Contract #: 04-0120F4Cty: SF/ALA Rte: 80 PM: 13.2/13.9File #: 69.25B**QUALITY ASSURANCE -- NON-CONFORMANCE REPORT****Location:** Changxing Island, Shanghai, China**Report No:** NCR-000899**Prime Contractor:** American Bridge/Fluor Enterprises, a JV**Date:** 23-Nov-2010**Submitting Contractor:** Zhenhua Port Machinery Company, Ltd (ZPMC), Changxing Island**NCR #:** ZPMC-0861**Type of problem:**

Reference Description: Weld Procedure Requirements for New Welds Not Followed**Description of Non-Conformance:**

To: AMERICAN BRIDGE/FLUOR, A JV **Date:** 24-Nov-2010
 375 BURMA ROAD
 OAKLAND CA 95607 **Contract No:** 04-0120F4
 04-SF-80-13.2 / 13.9
Dear: Mr. Charles Kanapicki **Job Name:** SAS Superstructure
Attention: Mr. Thomas Nilsson Project/Fabrication Manager **Document No:** 05.03.06-000857
Subject: NCR No. ZPMC-0861

The weld is identified as DP3091-001-180

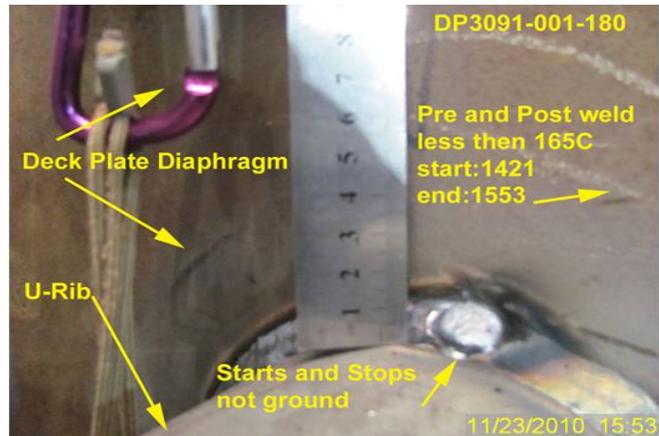
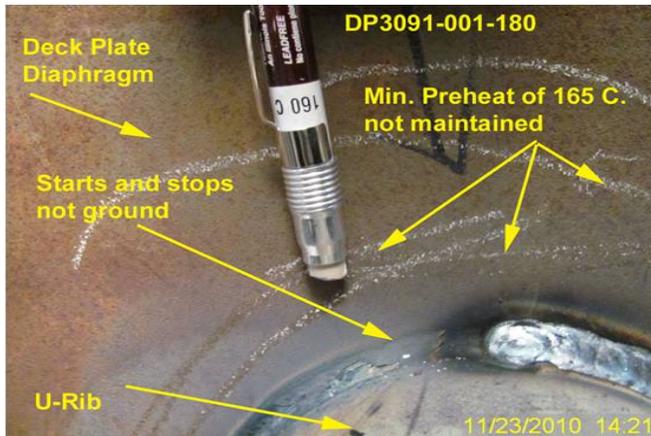
During Caltrans Quality Assurance in process observations of the fabrication of Deck Plate Segment Assembly, QA discovered the following issue(s):

ZPMC welding personnel did not appear to be following the NEW WELD PROCEDURE (Rager/McQuaid)

The following requirements were not followed:

3. Preparation for welding (3L)
4. Welding (4A, 4C, 4E)
5. Postweld Thermal Treatment (5A, 5B)

The welding process used was FCAW

The area was being preheated using Torch

The weld is a CJP and Fillet joining U-Rib to Deck Plate Diaphragm

Weld number DP3091-001-180 is located in Bay 14 for Segment 13BE.

Propose a resolution for the identified non-conformance with revised procedures to prevent future occurrences. A response for the resolution of this issue is expected within 7 days.

Contractor will provide the NDT report to prove the weld is acceptable.

Contractor submitted the NDT report. The report shows the weld is acceptable.
